VI. TEXT AMENDMENTS

The report covers Santa Clara Square LLC's Planned Development rezoning application to allow the construction of a mixed use development of up to 490 residential units, up to 12,300 square feet of office space and up to 171,000 square feet of commercial/retail space on approximately 12.6 acres on the southwesterly quadrant of El Camino Real and Lawrence Expressway. The 171,000 square feet of commercial/retail space includes ~~141,711~~ 147,741 square feet of commercial/retail space that is currently on the site.

Figure 11

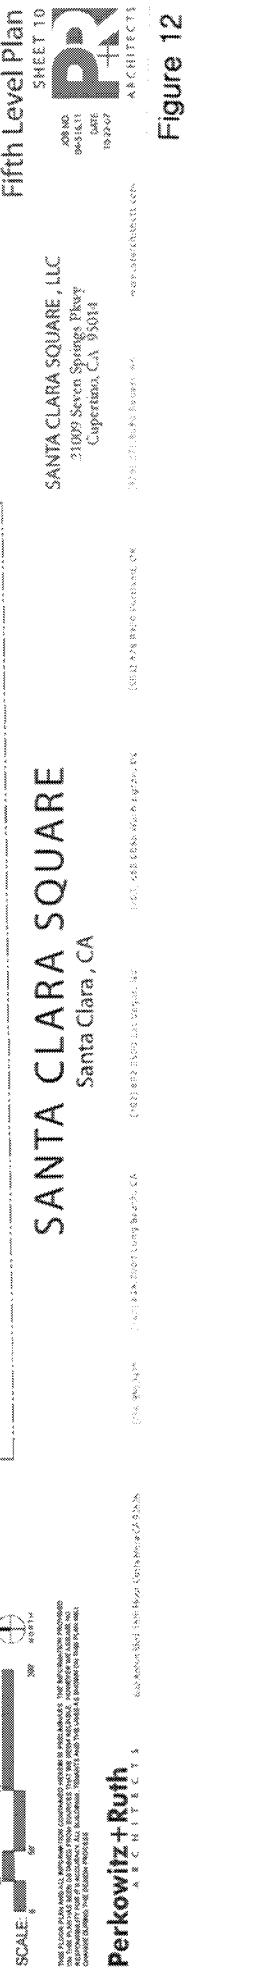
pages 19, 20 and 21 Replace the First Level Plan, Figure 11; Fifth Level Plan, Figure 12; and Eighth Level Plan, Figure 13 with the following plans.

Existing Trees

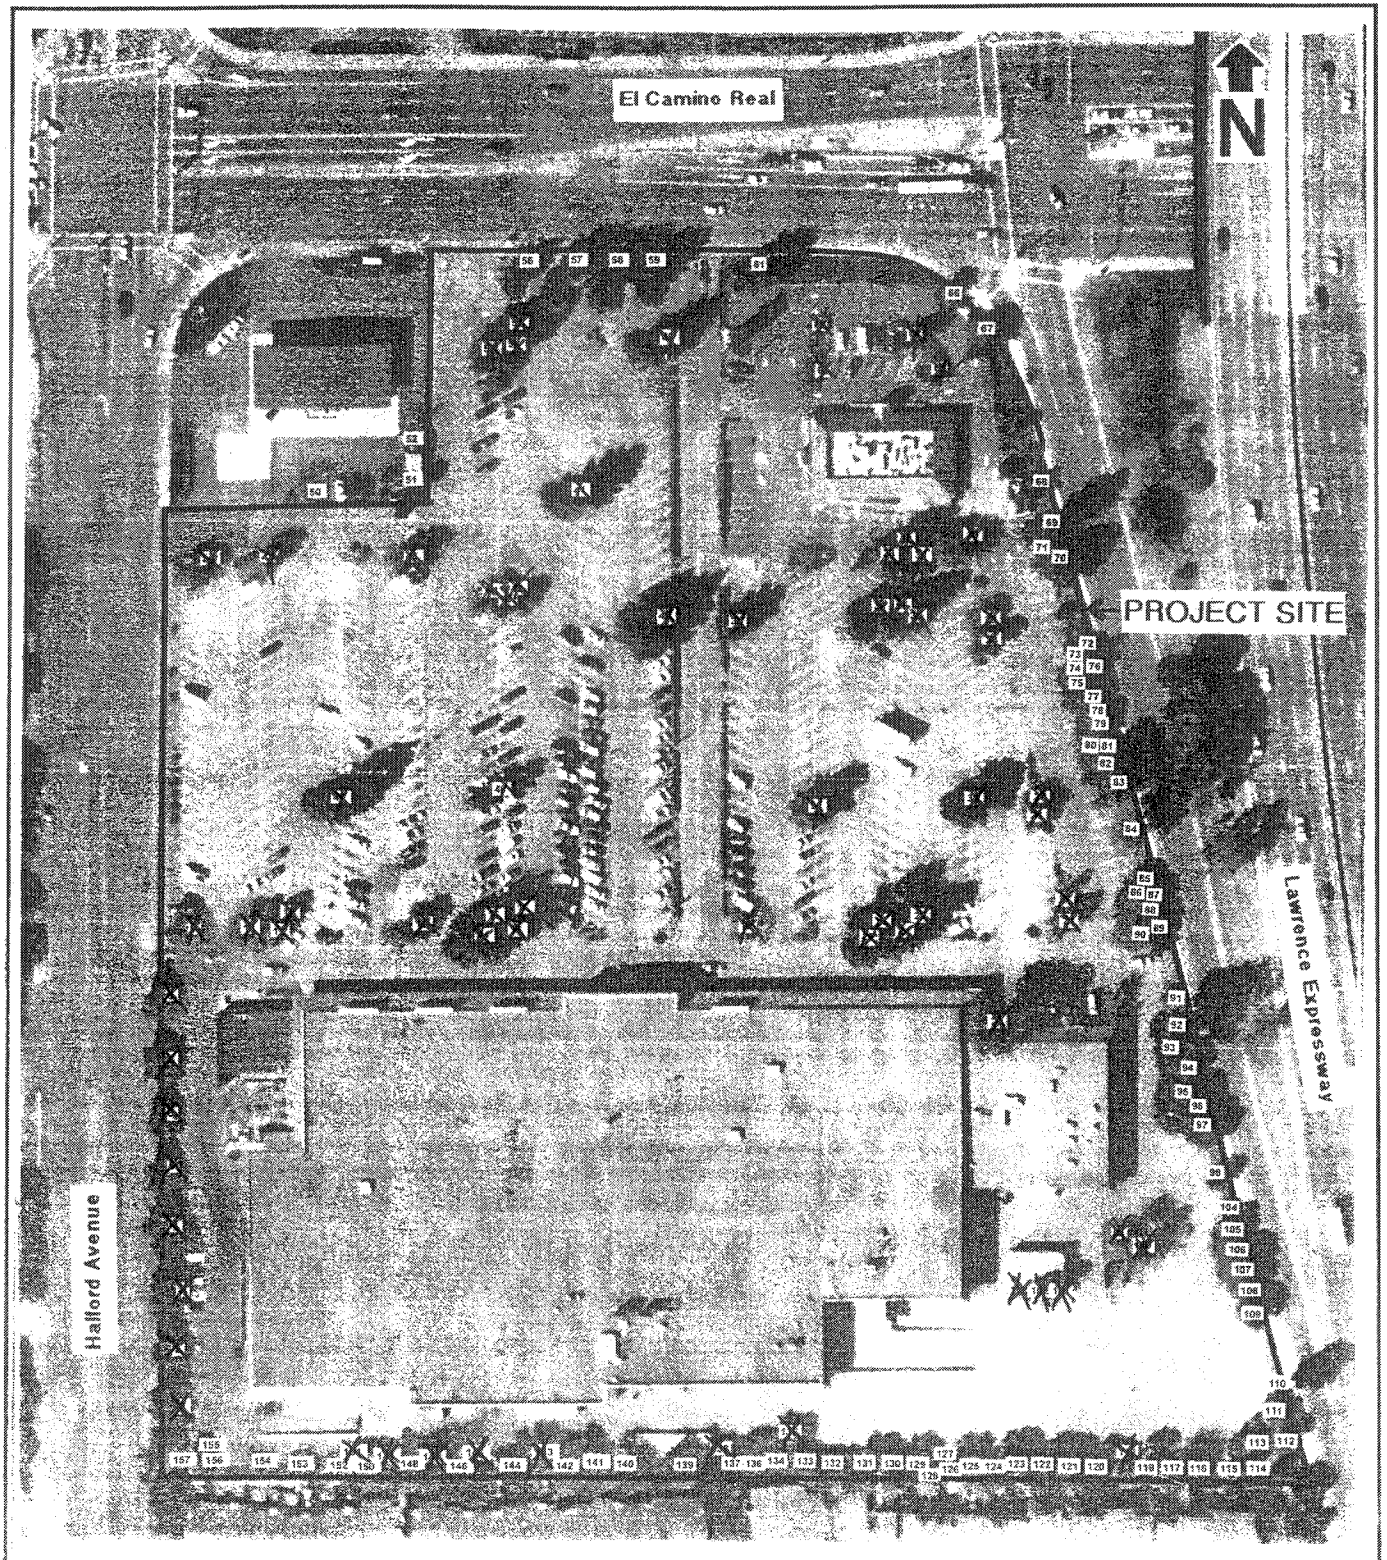
Revise the Existing Trees table and Trees to be Removed figure in Appendix B as follows:

Tree Nos. 1 – 8 added to removal list.
